11-AFC-1

**Re: Pio Pico Energy Center Project (11-AFC-01)
Correspondence to USEPA, Region 9**

Subject: Pio Pico Energy Center PSD Permit Application

Otay Mesa – 1st Quarter, 2005

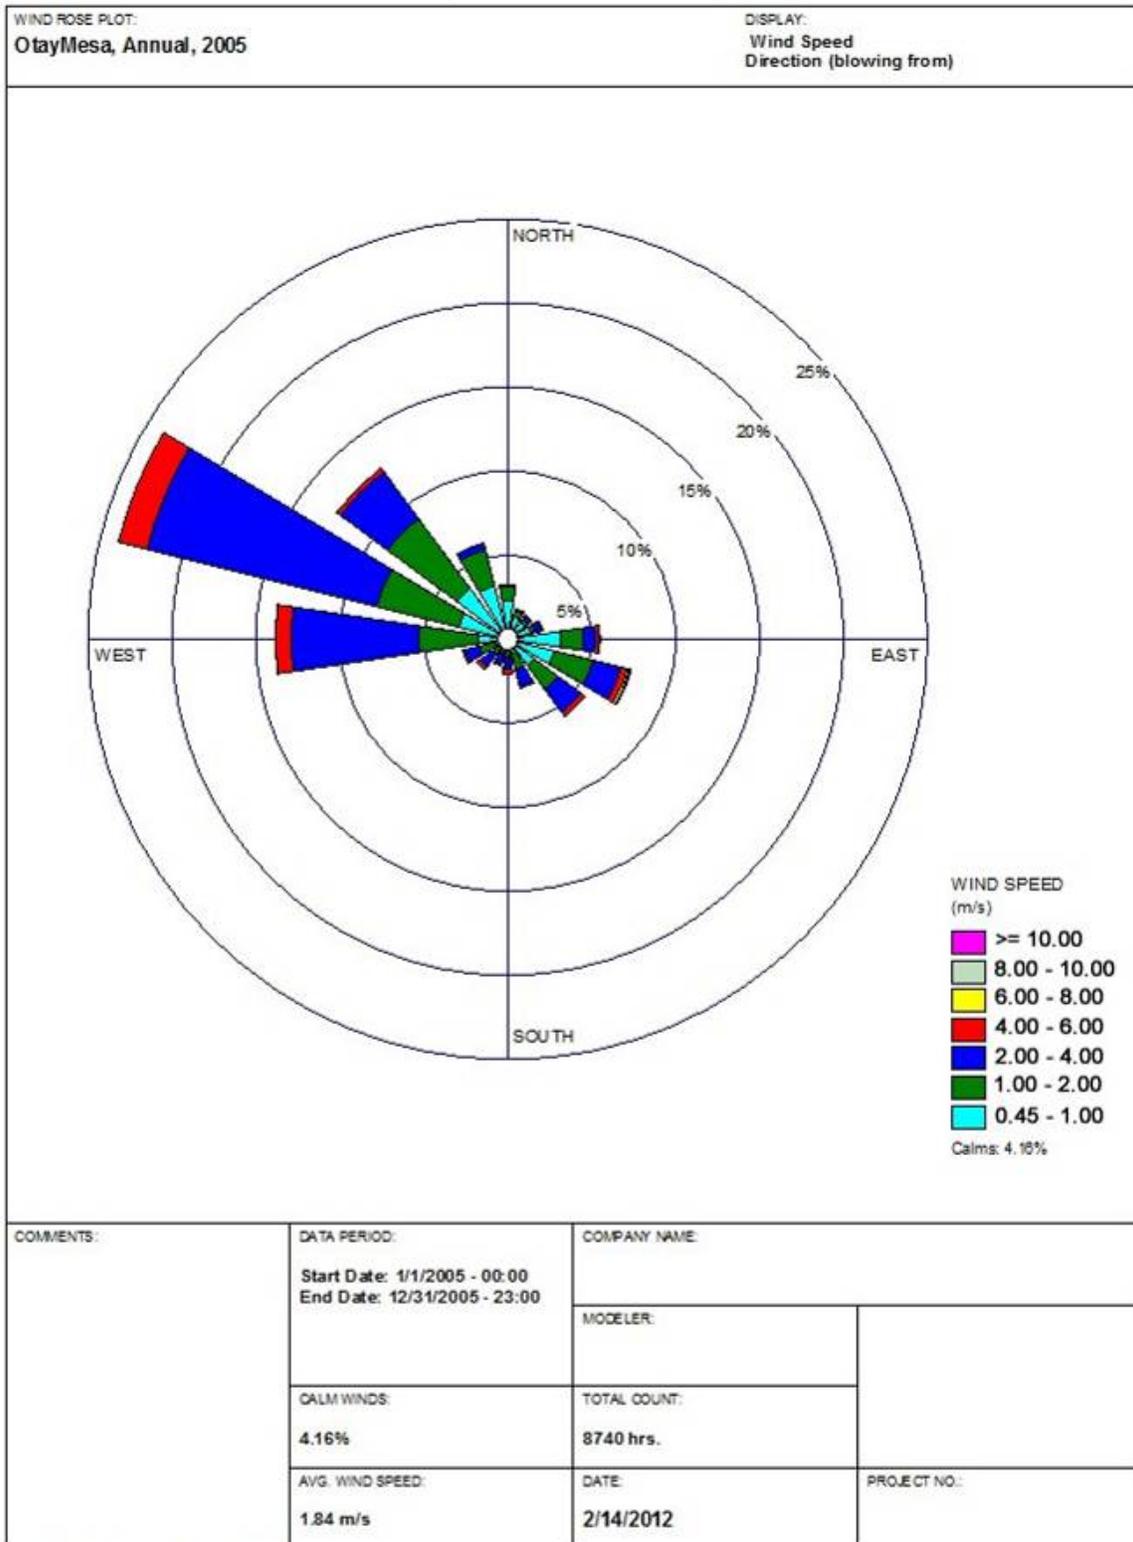
Comment: Please provide new wind rose graphics based on the definition of “calm” periods used in the modeling.

Response: In order to reduce the amount of time where wind speed is treated as “calm,” the San Diego Air Pollution Control District (SDAPCD or District) defines wind speeds below 0.45 m/sec as “calm” (standard definition is 0.5 m/sec). Charts were provided in the PSD application that graphically summarize quarterly and annual distributions of wind speed and direction (“wind roses”). The wind roses that were provided in the application used the standard cutoff for calm periods. EPA requested that Applicant provide wind roses that use the same cutoff used by the Applicant, following District guidance, in the modeling; the requested wind roses are attached.
